UNITED STATES
NUCLEAR REGULATORY COMMISSION
WASHINGTON, D. C. 20555

May 10, 1989

The Honorable Bill Lowery
United States House of Representatives
Washington, D. C. 20515

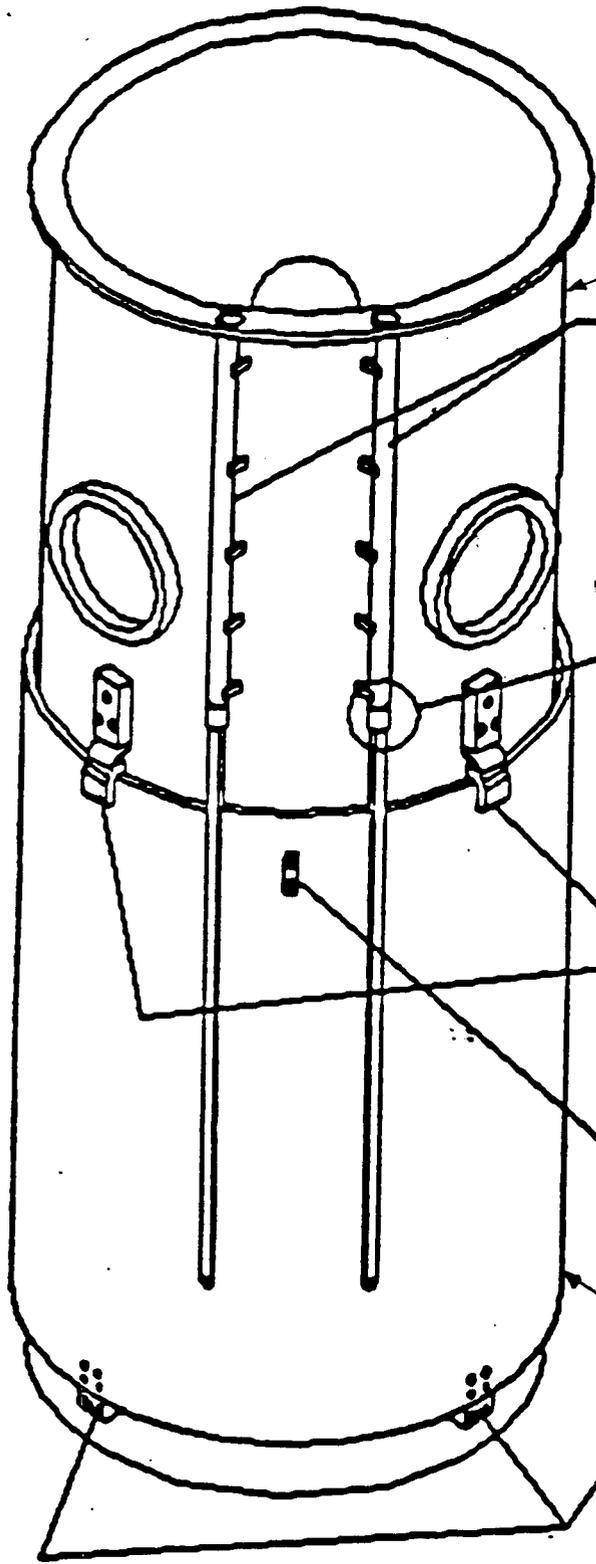
The thermal shield (see enclosed diagram) is a 2-1/2 inch thick cylinder that surrounds the reactor core barrel. Its purpose is to absorb gamma rays emitted by the reactor to reduce heating and consequent thermal stress in the reactor vessel wall. The thermal shield also absorbs high-energy neutrons, reducing irradiation damage to the vessel wall. Bolts are used to attach the bottom of the thermal shield to the core barrel, and spring-like devices called flexures are attached at the top. Four lateral displacement limiters are also located at the top.

On January 3, 1989, Southern California Edison conducted a visual inspection of the thermal shield with a remote camera; 24 of 30 bolts could be visually inspected. Three bolts out of the 24 inspected were found to be broken. In addition, the locking devices for two bolts and the locking device for one dowel pin had cracks. Five out of six flexures at the top of the thermal shield have been broken since 1978. The flexures were originally added to provide radial and tangential restraint to the top of the thermal shield. When these were discovered to be broken, an evaluation was made which concluded that the flexures were unnecessary. As a result of the January inspection, the licensee found no evidence of damage to or motion of the thermal shield.

FLEXURE FIXTURE 5 OF 6 BROKEN OR CRACKED SINCE 197
 (TYP 6 PLACES) NO CHANGE NOTED

5 BOLTS PER SUPPORT BLOC:
 3 BOLTS (TOTAL) BROKEN
 AFFECTING 2 OF 6 SUPPORT:

The staff has reviewed the analysis and concurs with the licensee's evaluation subject to the implementation of the monitoring program and mid-cycle inspection. The review fully addressed the structural integrity of the thermal shield supports, the licensee's ability to monitor significant changes, and the acceptability of the consequences of a failure of the thermal shield supports. The staff is in the process of finalizing a license amendment which would allow operation as proposed.

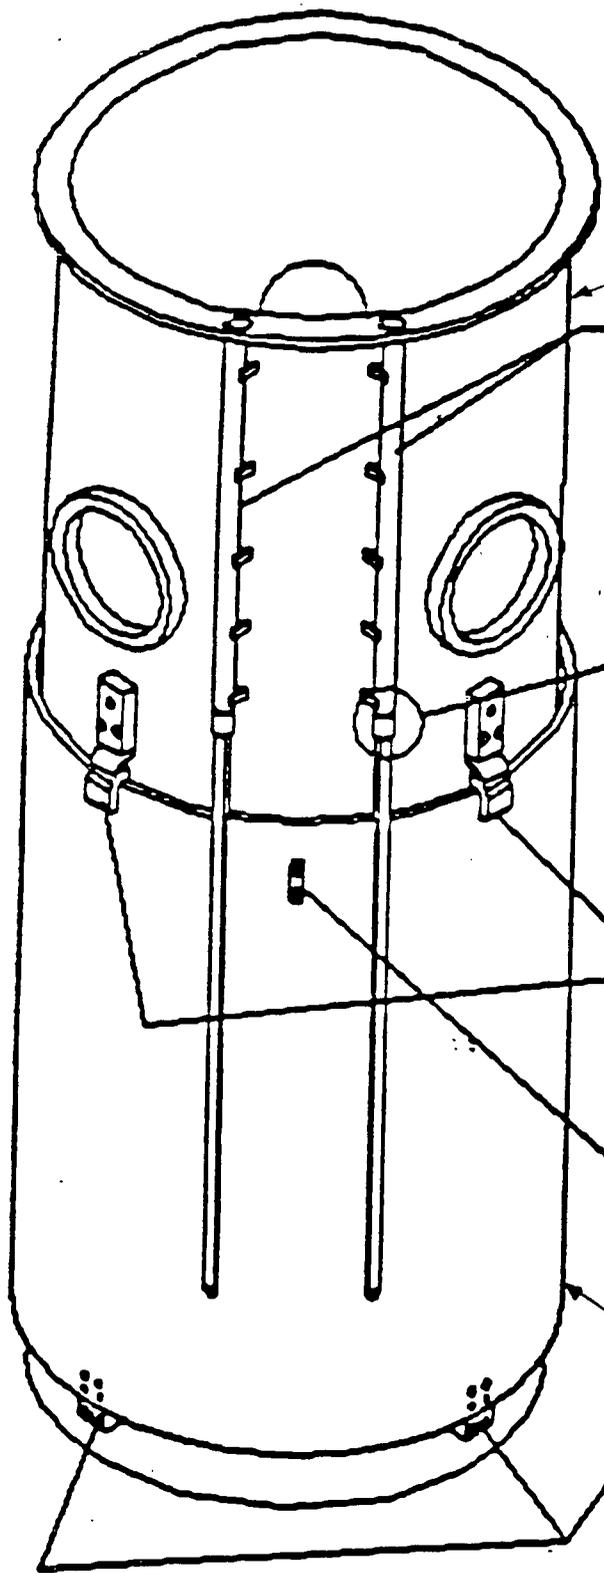
The thermal shield (see enclosed diagram) is a 2-1/2 inch thick cylinder that surrounds the reactor core barrel. Its purpose is to absorb gamma rays emitted by the reactor to reduce heating and consequent thermal stress in the reactor vessel wall. The thermal shield also absorbs high-energy neutrons, reducing irradiation damage to the vessel wall. Bolts are used to attach the bottom of the thermal shield to the core barrel, and spring-like devices called flexures are attached at the top. Four lateral displacement limiters are also located at the top.

On January 3, 1989, Southern California Edison conducted a visual inspection of the thermal shield with a remote camera; 24 of 30 bolts could be visually inspected. Three bolts out of the 24 inspected were found to be broken. In addition, the locking devices for two bolts and the locking device for one dowel pin had cracks. Five out of six flexures at the top of the thermal shield have been broken since 1978. The flexures were originally added to provide radial and tangential restraint to the top of the thermal shield. When these were discovered to be broken, an evaluation was made which concluded that the flexures were unnecessary. As a result of the January inspection, the licensee found no evidence of damage to or motion of the thermal shield.

FLEXURE FIXTURE (TYP 6 PLACES) 5 OF 6 BROKEN OR CRACKED SINCE 19
NO CHANGE NOTED

5 BOLTS PER SUPPORT BLOC
3 BOLTS (TOTAL) BROKEN
AFFECTING 2 OF 6 SUPPOR

The staff has reviewed the analysis and concurs with the licensee's evaluation subject to the implementation of the monitoring program and mid-cycle inspection. The review fully addressed the structural integrity of the thermal shield supports, the licensee's ability to monitor significant changes, and the acceptability of the consequences of a failure of the thermal shield supports. The staff is in the process of finalizing a license amendment which would allow operation as proposed.

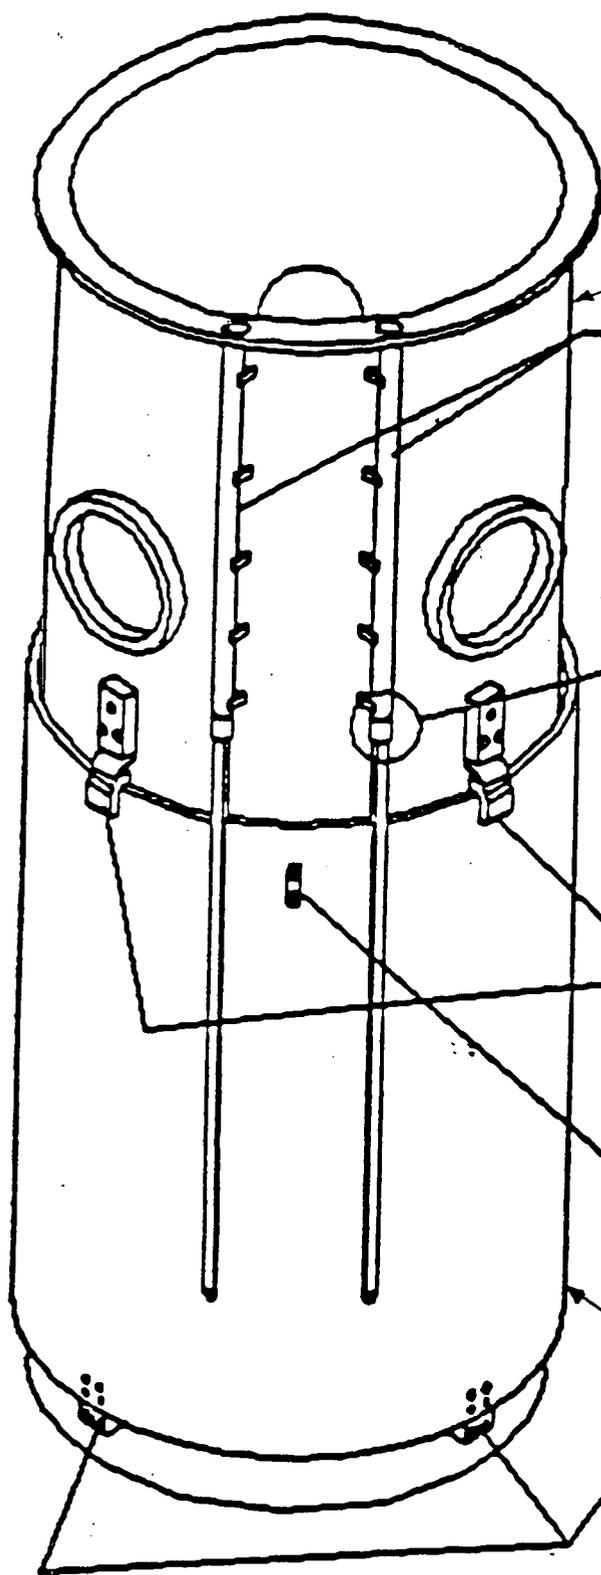
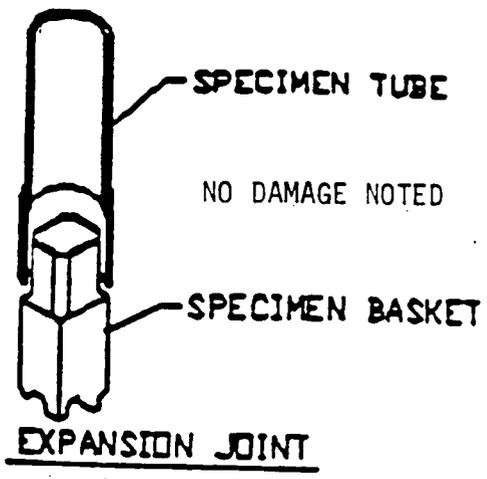
The thermal shield (see enclosed diagram) is a 2-1/2 inch thick cylinder that surrounds the reactor core barrel. Its purpose is to absorb gamma rays emitted by the reactor to reduce heating and consequent thermal stress in the reactor vessel wall. The thermal shield also absorbs high-energy neutrons, reducing irradiation damage to the vessel wall. Bolts are used to attach the bottom of the thermal shield to the core barrel, and spring-like devices called flexures are attached at the top. Four lateral displacement limiters are also located at the top.

On January 3, 1989, Southern California Edison conducted a visual inspection of the thermal shield with a remote camera; 24 of 30 bolts could be visually inspected. Three bolts out of the 24 inspected were found to be broken. In addition, the locking devices for two bolts and the locking device for one dowel pin had cracks. Five out of six flexures at the top of the thermal shield have been broken since 1978. The flexures were originally added to provide radial and tangential restraint to the top of the thermal shield. When these were discovered to be broken, an evaluation was made which concluded that the flexures were unnecessary. As a result of the January inspection, the licensee found no evidence of damage to or motion of the thermal shield.

FLEXURE FIXTURE 5 OF 6 BROKEN OR CRACKED SINCE 19
 (TYP 6 PLACES) NO CHANGE NOTED

5 BOLTS PER SUPPORT BLC
 3 BOLTS (TOTAL) BROKEN
 AFFECTING 2 OF 6 SUPPOR

The staff has reviewed the analysis and concurs with the licensee's evaluation subject to the implementation of the monitoring program and mid-cycle inspection. The review fully addressed the structural integrity of the thermal shield supports, the licensee's ability to monitor significant changes, and the acceptability of the consequences of a failure of the thermal shield supports. The staff is in the process of finalizing a license amendment which would allow operation as proposed.
